AGENDA

Tuesday, March 17, 2015

TO: Chairman Jerome Kerner, AIA and
Members of the Lewisboro Planning Board

RE: Verizon Wireless Upgrade
1065 Route 35 (Town Park)
Sheet 21, Block 10541, Lots 5 and 25

DRAWING TITLE
COMPOUND PLAN,
ANTENNA ELEVATIONS,
PROJECT INFORMATION,
TOPOGRAPHIC MAP, AND NOTES

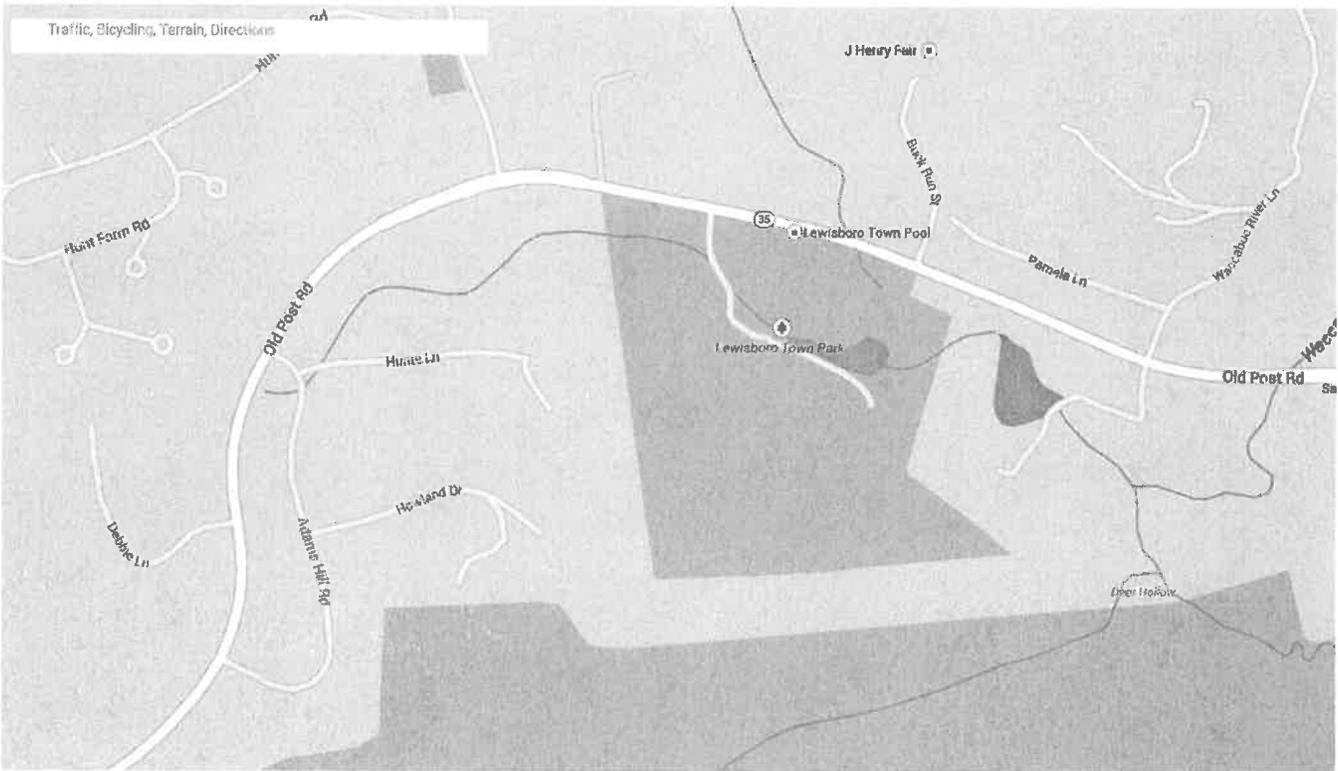
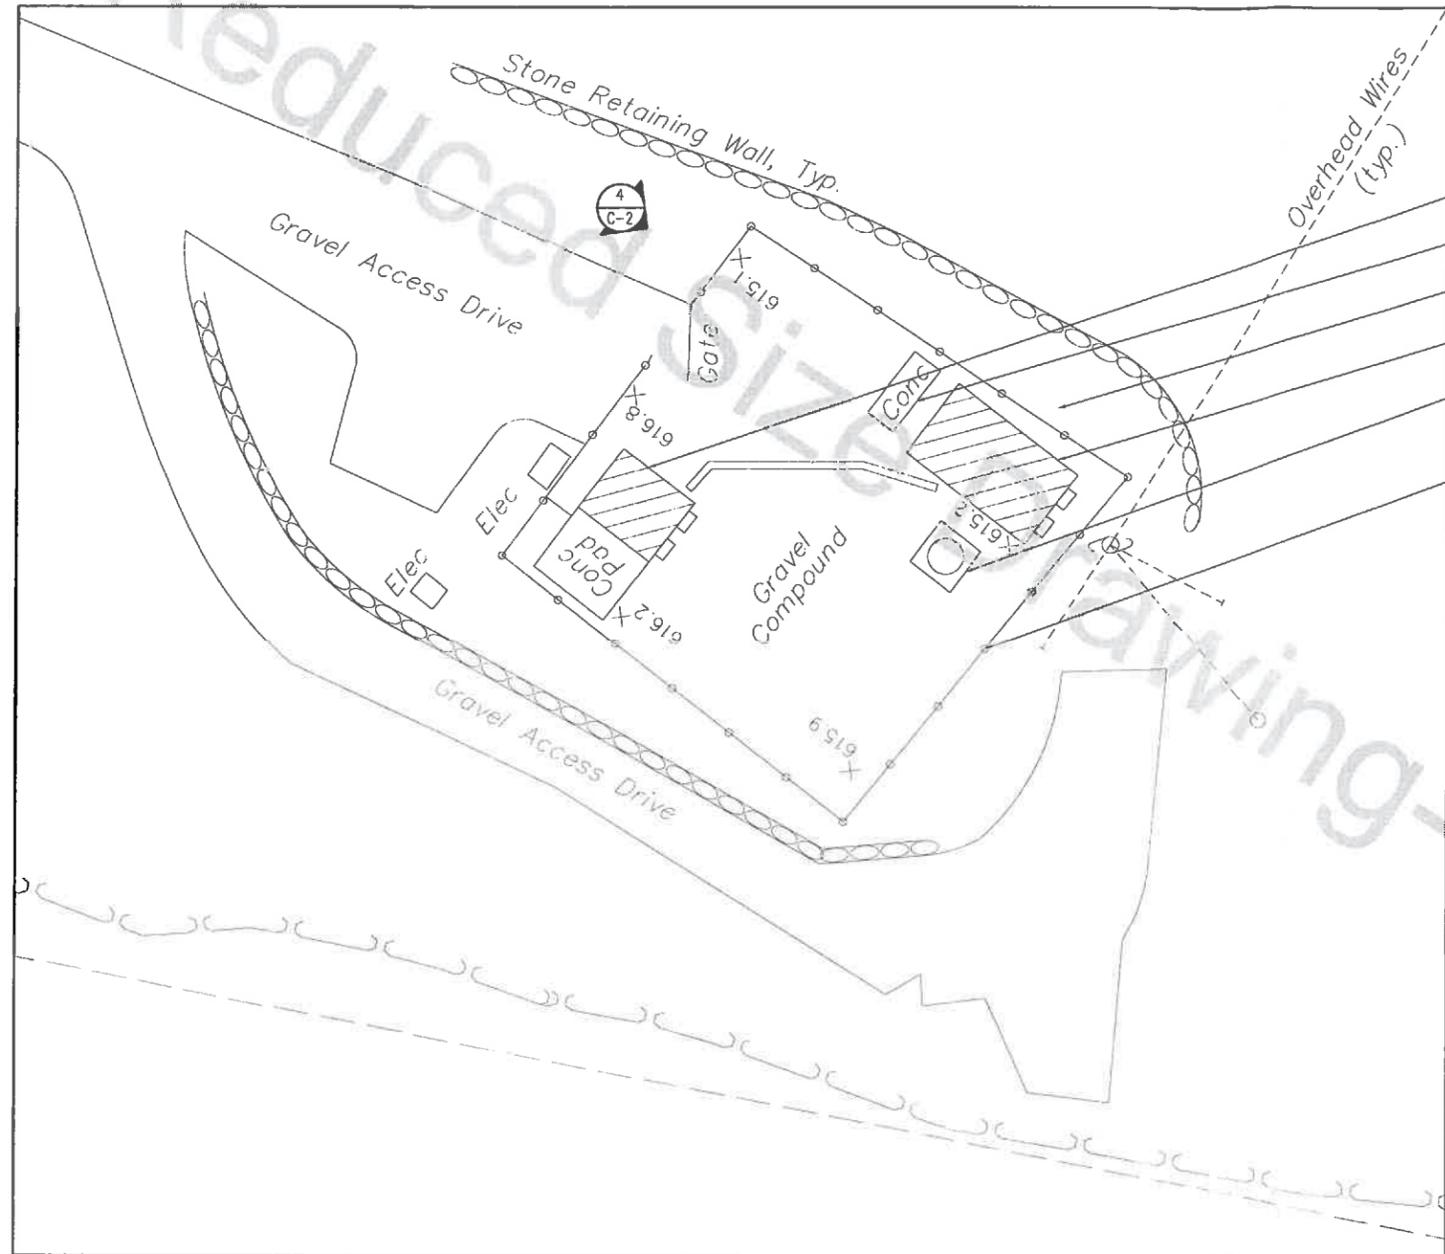
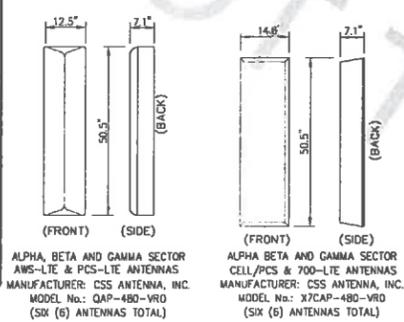
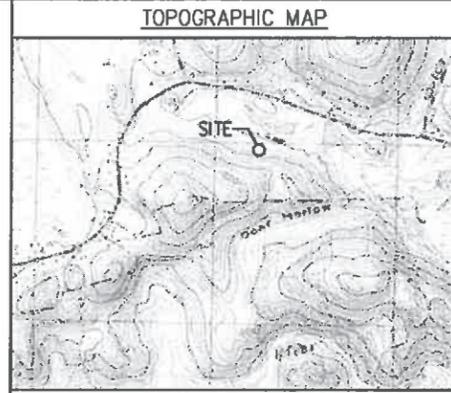
4. A calculation of the total existing and proposed antenna/equipment volume should be provided on the plans (cubic feet or cubic inches).
5. We note that the applicant has supplied a structural certification letter for the tower and an updated Radio Frequency (RF) Compliance Report.

- Pipeline Project Civil Site Plan (Sheet C1)
- Pipeline Project Civil Landscape Plan (Sheet C2)
- Pipeline Project Civil Details (Sheet D1)

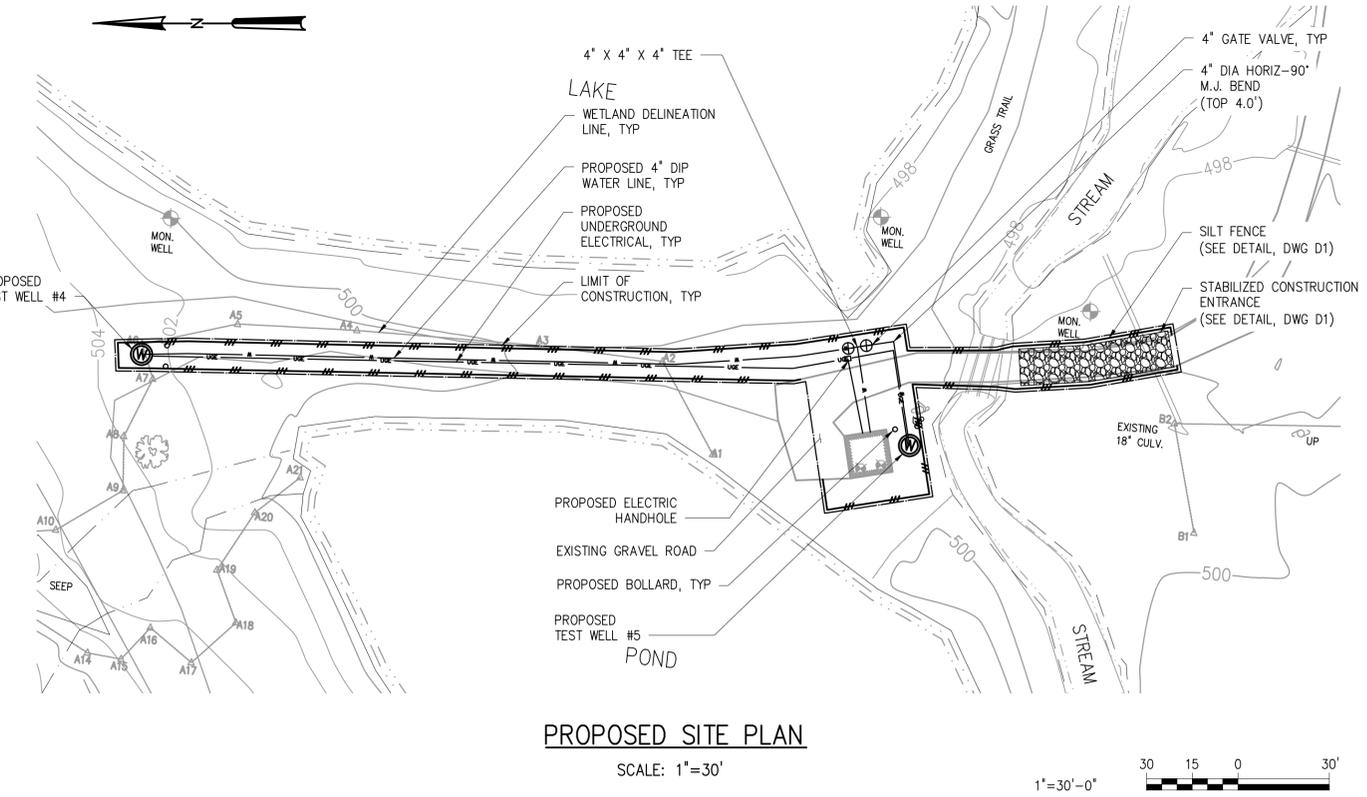
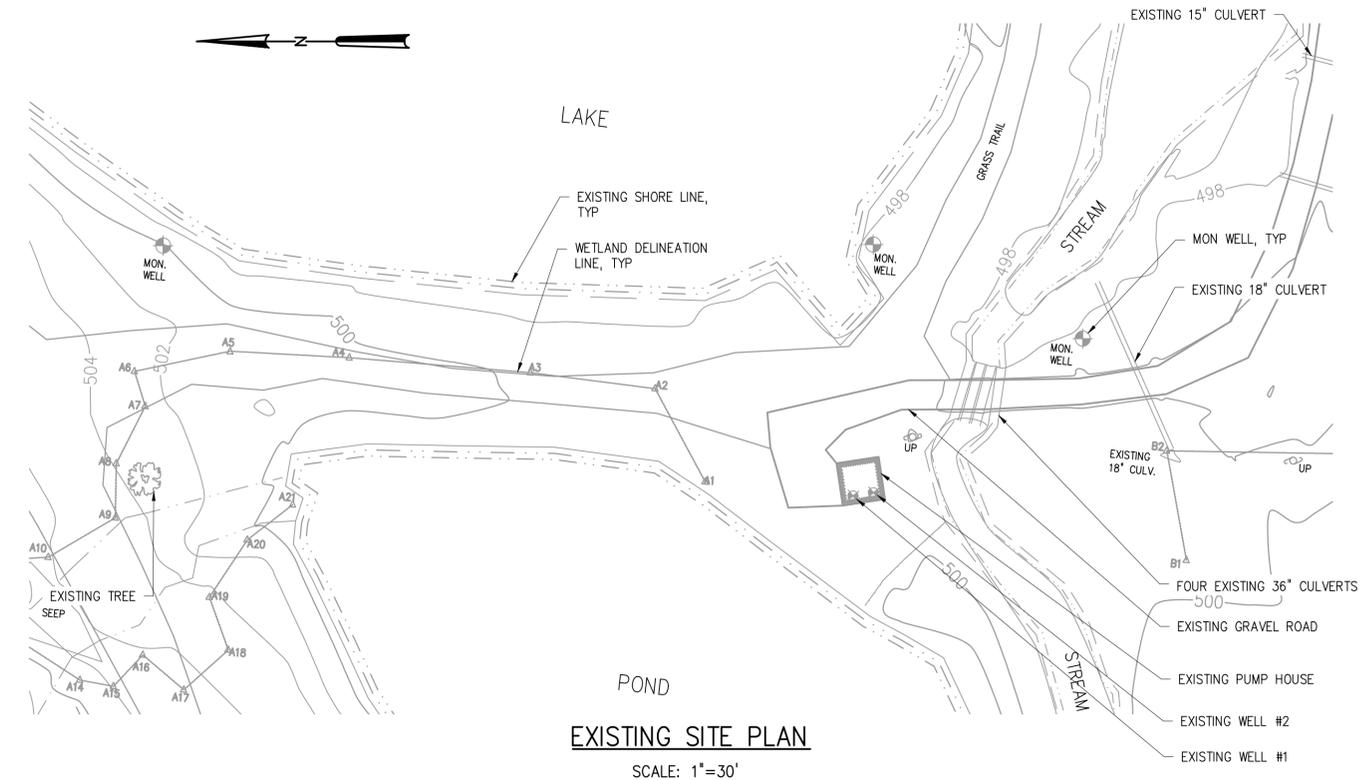
12. The Tax Parcel number provided on the wetland permit application form is not correct and should be revised (Sheet 8, Block 11137, Lot 39).
13. The plan should illustrate proposed locations for dewatering activities should the need arise during trench excavation for the service lines. Details for the protection and stabilization of the discharge point should be provided.
